## Department of Transportation

#### MEMORANDUM

**SUBJECT:** ZC Case No. 20-18 – 1319 South Capitol Street SW

Figure 1 – Site and Access Plan (Source: Gorove/Slade CTR, Figure 7, 9/11/2020)

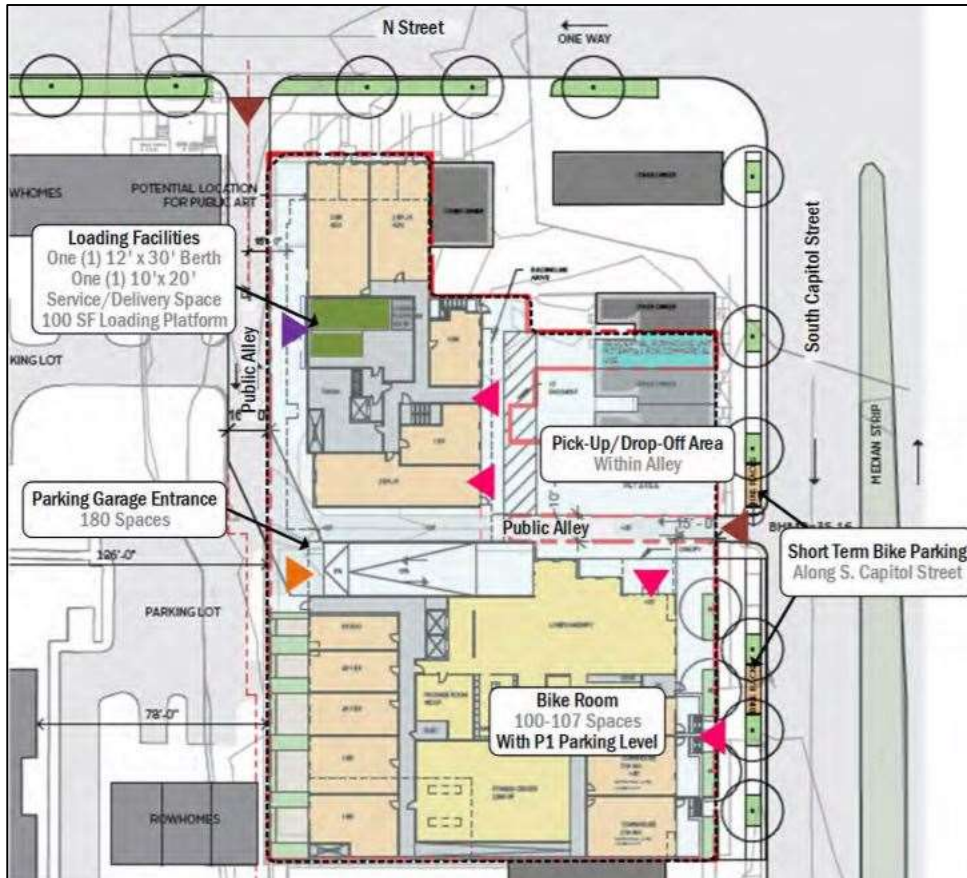
While the preliminary public space plans, shown above in Figure 1, are generally consistent with DDOT standards, there are several considerations that need to be reviewed in greater detail during the public space permitting process:

- Close the existing curb cut to S. Capitol Street SW just south of the east-west alley;
- Ensure the sidewalk along the both N Street and S. Capitol Street frontages line up straight with the sidewalks of adjacent properties and are of the same width;

- Install signage along the public and private portions of the 10-foot alley clarifying the circulation is one-way westbound;
- Ensure all building entrances are at-grade with the sidewalk to avoid unnecessary stairs and ramps in public space;

- Ensure any bollards in the off-street pick-up/drop-off concept are behind the property line and not within DDOT's alley or South Capitol Street right-of-way;

- Fences and gates may only be a maximum of 42 inches tall and of an open design;
- DDOT appreciates the creativity with the proposed alley design and pull of area. The non-standard materials will require a covenant of maintenance and the Applicant will be responsible for maintaining it;

- Extend the proposed 12-foot easement northward to the edge of Lot 830 to allow for access to Lots 829/830 when those properties redevelop. Also, provide an easement across the private portion of the 10-foot alley (Lot 831) so that the rowhouses can exit out the 16-foot public alley. A copy of the easement(s) should be provided to DDOT Planning and Sustainability Division when it is signed by all parties; and

Figure 4 – Pedestrian Facilities (Source: CTR, Gorove/Slade, Figure 27, 9/11/20)

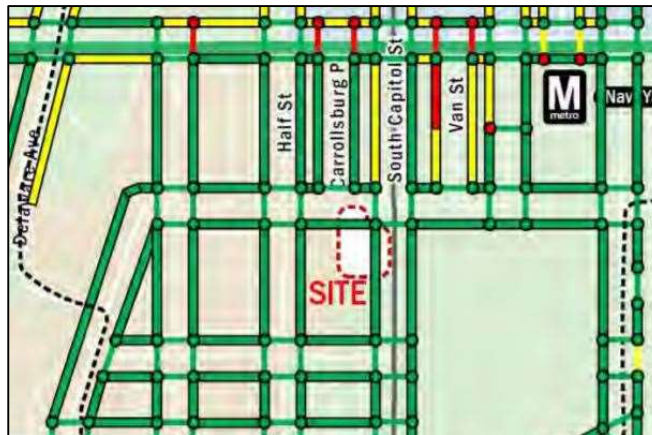
However, it is noted that in the graphic below, curb ramps and high visibility crosswalks are not shown as missing at the T-intersections of Delaware Avenue at Canal Street SW and O Street at Canal Street SW, three (3) blocks west of the site. DDOT requests the Applicant include the funding and installation of them in the TDM plan as mitigation to offset the intersection impacts and induced demand for driving from the high parking supply. These are along a critical walking path from the site to the Route 74 bus stops located adjacent to those two intersections and other waterfront amenities to the west.

- During public space permitting, include plans for the missing curb ramps and high visibility crosswalks at the intersections of Canal Street at Delaware Avenue SW and Canal Street at O Street SW; and
